Planning Commission Meeting

- PLANNING COMMISSION AGENDA ITEM: 7A
- APPLICATION NUMBER: DPLF-2025-000266
- PROPERTY ADDRESS: 6408 PINE AVENUE TAX PARCEL NUMBER 11-46-21-T1-0030B.0300

6408 Pine Avenue

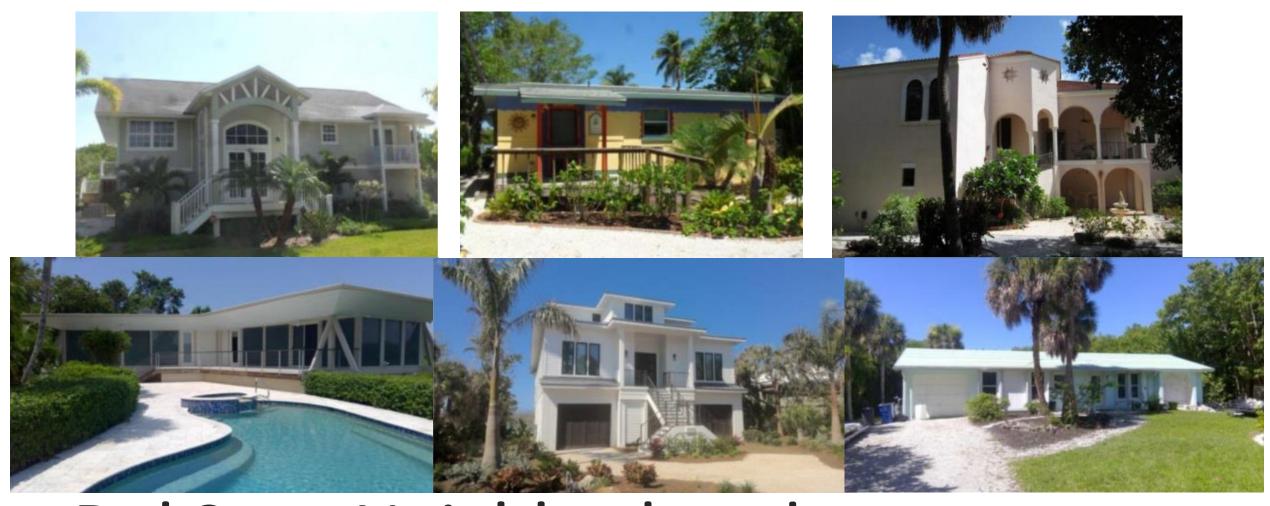
- The proposed single-family residence meets the objectives stated in Sec. 86-43(a) to maintain the character of Sanibel through ensuring the appearance and mass of new houses are compatible with the neighborhood and community and do not interrupt the rhythm, harmony and character of an established neighborhood.

- The proposed single-family residence is consistent with Sec. 86-43(b)(1) standard requiring a new house shall not interrupt the rhythm of existing structures in the established neighborhood.

- The proposed single-family residence meets the standard of Sec. 86-43(b)(2) requiring that size, bulk, mass, height, or location or orientation on the lot of a new house shall not unreasonably infringe upon the adjoining property owner's enjoyment of his/her property in terms of air circulation and access to natural light.
